**Appendix I – Response to Comments on the 90% Design Documents (Basis of Design Report, O&M Manual, Construction/Remedial Action Work Plan)**

Groundwater Remedy Basis of Design Report/Final (100%) Design

PG&amp;E Topock Compressor Station, Needles, California

### **Transwestern Bench and MW-20 Bench – Consolidation of Carbon Storage/Dosing Design and Operations**

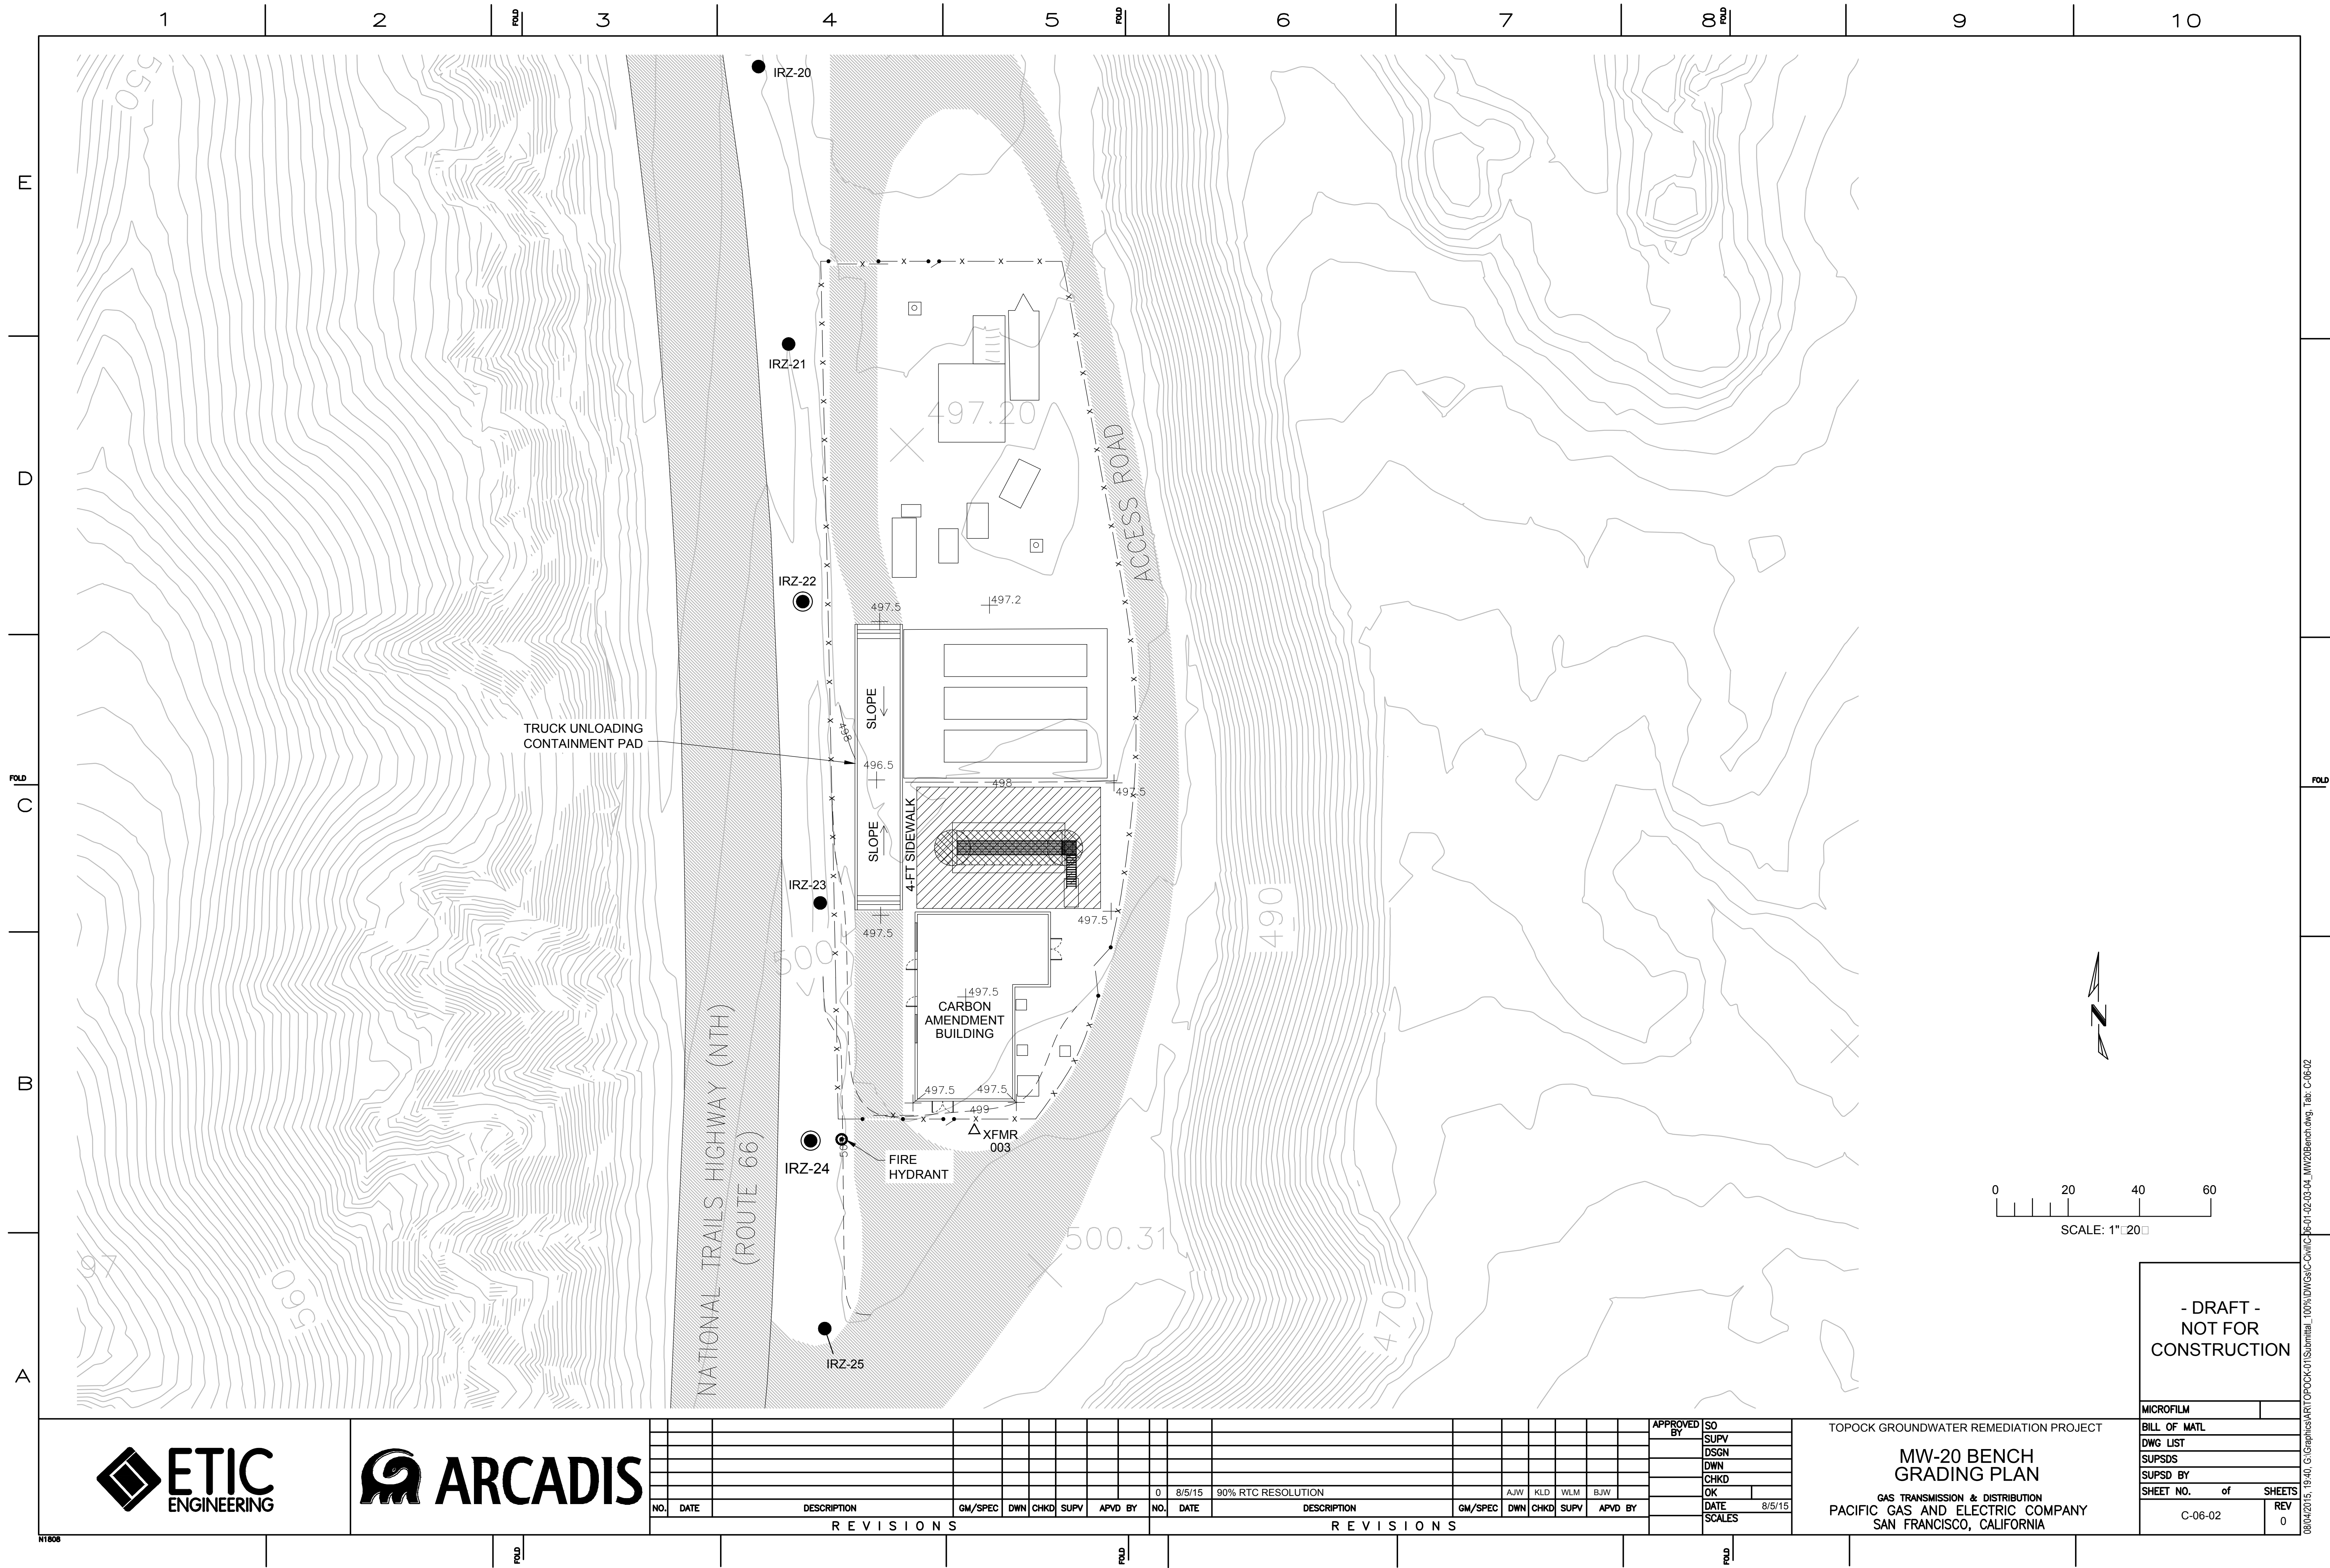
134	DTSC-18	Design	Infrastructures	Figure ES-4A	MW-20 Bench	Aside from the additional carbon amendment building and storage tanks, will all other structures	Not all IM features on	See RTC # 1152			Comment resolved.

*The final design will address DTSC's comments and will replace the leach field at the TW Bench with a septic tank (specifically Drawings C-008-03 and C-008-04.*
